Reply on RC1

Author comment on "Soil moisture estimation in South Asia via assimilation of SMAP retrievals" by Jawairia A. Ahmad et al., Hydrol. Earth Syst. Sci. Discuss.,
<https://doi.org/10.5194/hess-2021-460-AC2>, 2021

Reviewer #1

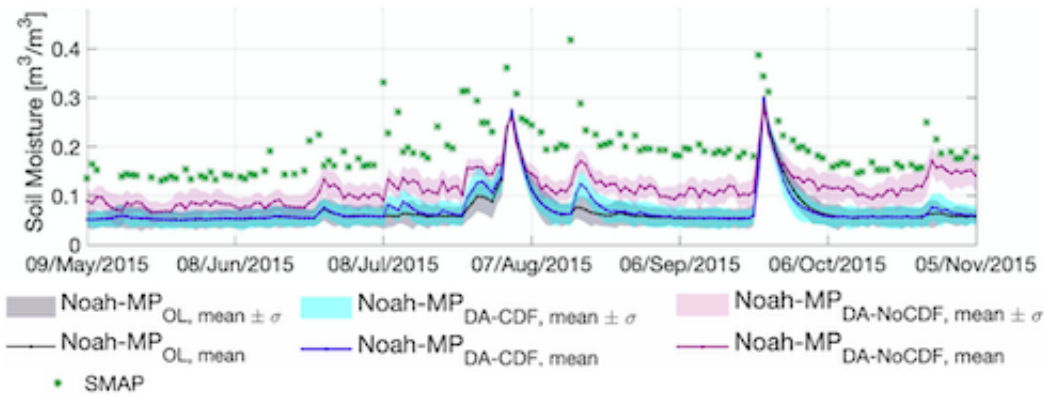
- MAJOR: The main problem with the paper is that the better results are obtained when SMAP soil moisture data are assimilated without the correction of the BIAS. Of course, the correction of the BIAS in regions in which we have irrigation, that is not modelled by the Noah-MP version used in this study, will provide wrong results. However, without the correction of the BIAS, i.e., no CDF-matching (or other methods), the assimilation method is not correct as well. Indeed, the assimilation should correct the random error, not the BIAS. The bias between modelled and satellite data is related to multiple causes, differences in spatial scale, differences in parameterization (e.g., wilting point and saturation), differences in land cover specification. A BIAS between modelled and satellite data is expected. For instance, a positive BIAS is observed also in the summer period (see Figure 4 and 7) or in areas not irrigated (Figure 4), and it cannot be easily explained. I am sure that in Pakistan and northern India the satellite soil moisture data can contribute to see the unmodelled irrigation and hence to contribute to improve land surface modelling. However, the approach used in the study should be corrected. E.g., the Noah-MP model with the irrigation module can be run. BIAS correction only during summer (i.e., in which irrigation is negligible) can be implemented (not month by month). These are just two suggestion to the authors.

As an alternative, assimilation using an anomaly-based approach (i.e., one that is zero-mean by construct) was also tested. In the interest of limiting the scope of the study, these results were not added in the paper. In this approach, the retrieval mean was mapped to the land surface model mean and updates were computed using the resultant anomalies such that:

Figure A shows a sample timeseries for a location that is 80% irrigation-equipped. It is apparent that assimilation estimates (DA-CDF) after anomaly scaling closely mimic the OL estimated soil moisture throughout the year whereas DA-NoCDF is able to update the soil moisture based on the information in the SMAP observations, particularly during the winter months. This could be further explored if in-situ measurements were available. Unfortunately, there are no publicly available soil moisture datasets across the three primary river basins in South Asia, i.e., Indus, Ganges, and Brahmaputra, from 2015 onwards.

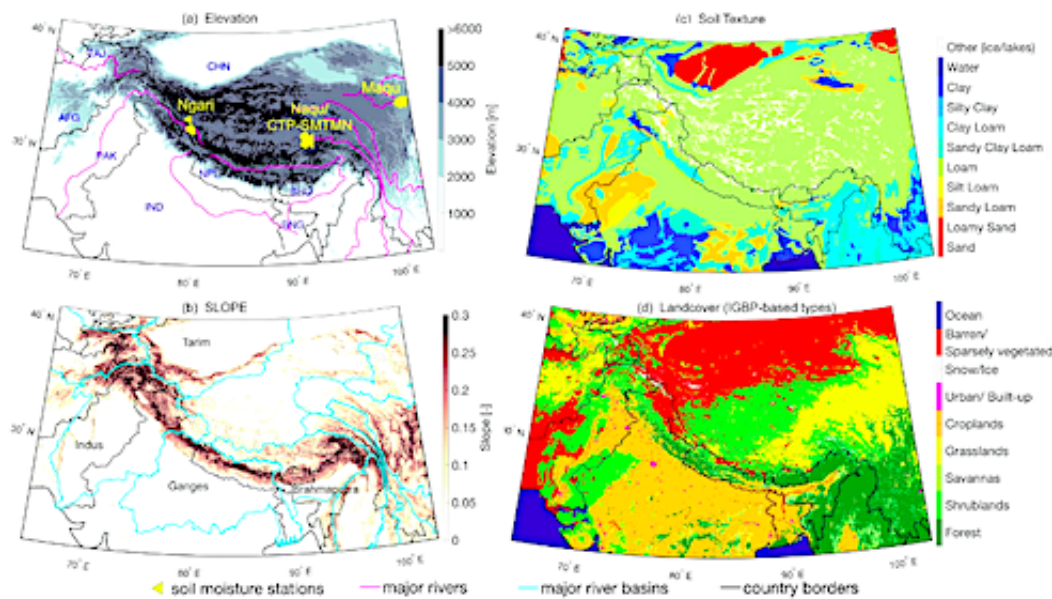
- P1, Title: Please change by considering the general comment above.

Response: The title has been partially modified according to the referee's recommendation to:

"Soil moisture estimation across South Asia via SMAP retrieval assimilation"
